### AMENDMENTS TO THE DRAWINGS

Appl. No. 10/781,523 Amdt. Dated Feb. 2, 2006 Reply to Office Action of 11/08/2005

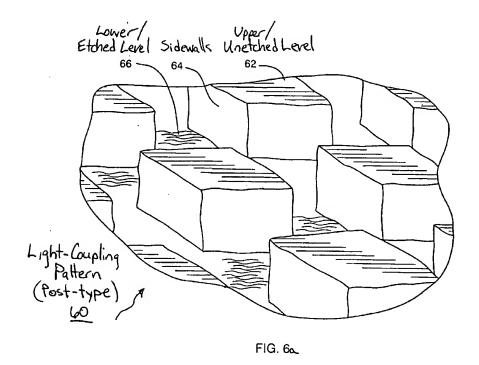
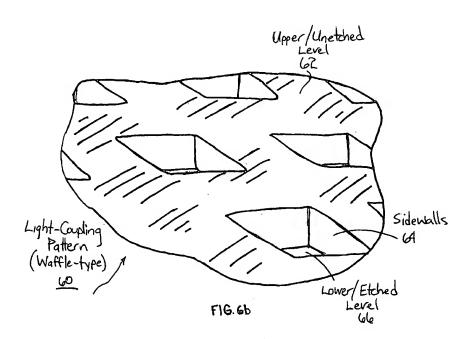
- FIG. 1 handwritten text replaced with typed text
- FIG. 2 handwritten text replaced with typed text
- FIG. 4 handwritten text replaced with typed text
- FIG. 6a handwritten text replaced with typed text; label "Light-Coupling Pattern (Post-type) 60" has been amended to "Light-Coupling Pattern (Post-type) 70" to more clearly distinguish the post type grating from the waffle type grating.

- FIG. 6b handwritten text replaced with typed text; label "Light-Coupling Pattern (Waffle-type) 60" has been amended to "Light-Coupling Pattern (Waffle-type) 80" to more clearly distinguish the post-type grating from the waffle-type grating.

Applicant believes that the specification and drawings clearly illustrate a waffle configuration, wherein the structure resembles a waffle having wells instead of posts. For illustrative purposes, Applicant directs the Office to Figures 6a and 6b of the present application which are presented herein. Figure 6a shows a number of posts while Figure 6b shows a waffle configuration with wells etched out, leaving the grid lines in relief to form the sidewalls of the wells and the lower level forming the floor.

posts to leave the posts. For clarification purposes, the claims have been amended to match the specification description with respect to 'wells' in stead of 'holes', as the wells of the present invention have sidewalls (Fig. 6b - 64) and a lower level (Fig. 6b - 66)

In distinction to the post configuration, the electromagnetic waves first encounter the reflector grid (Fig. 6a - lower level) which is closer to the quantum wells than the reflector islands (Fig. 6a – upper level).

In more particular detail, Applicant has amended Figure 6a to denote the post-type grating as element 70 and the waffle-type grating of Figure 6b is denoted as element 80. Figure 7a has been amended to include a reference label for "Pixel 90" to note that the structure is a pixel. This aids in understanding the orientation of the grating 60 on the pixel 90, wherein the grating is oriented to the edges of the pixel 90. Reference number "60", "62", "66" has been added to more clearly identify the "Light-Coupling Grating Pattern 60" and the "Posts 62" and "Wells 66". The term "Holes" has been amended to "Wells" to more clearly identify the well structures. This is for clarification purposes and corresponding changes to the specification are included herein.

FIG. 2

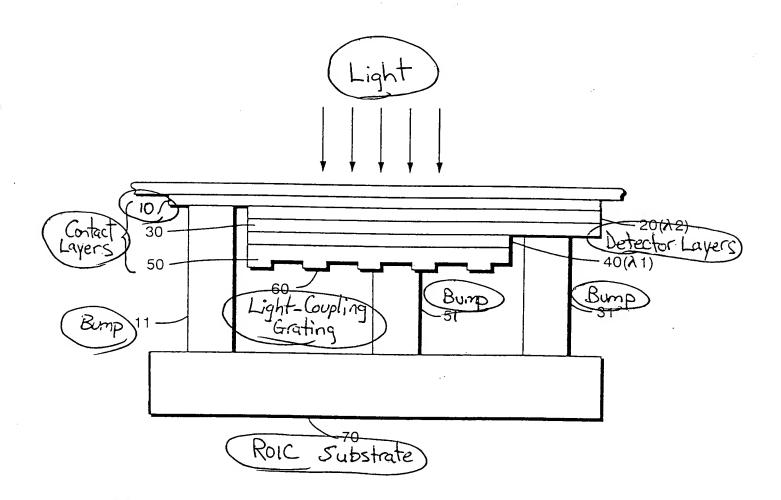
Handwritten text replaced with typed text
